SERVICE BULLETIN NO. 182 R1

E-60 & E-60H MOTOR REPLACEMENT

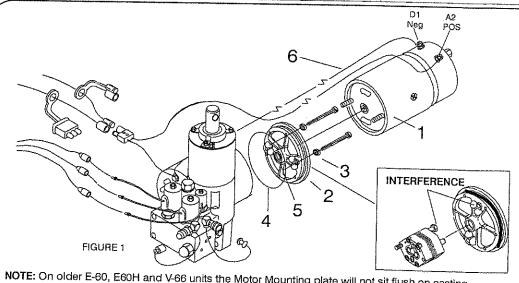
Under Meyer Products continuing Products Improvement Program, the E-60 and E-60H electric motor part number 15689 (12V) and 15767 (24) Single Terminal, used in production and for service replacement will no longer be available. A new two terminal motor with separate terminals for (+) positive and (-) negative cable connections is now available.

Service replacement of the single terminal motors require a new motor mounting plate be installed due to the drain hole location on the new two terminal motor, an extra ground cable to be attach to the D1 (-) terminal on the electric motor. This ground cable should be attached along with the standard ground cable to the grounding stud on the hydraulic unit then to the D1 (-) terminal on the electric motor, per illustration.

NOTE: On older E-60, E60H and V-66 units the Motor Mounting plate will not sit flush on casting, there is an interference problem. One of the bosses located on the new motor mounting plate interfers with a bolt head used to attach the Fenner pump to the sump casting. Due to the height of the Fenner Pump one of the bolts will require that the head of the bolt be ground down to clear boss during assembly.

DO NOT GRIND ON THE MOTOR MOUNTING PLATE.
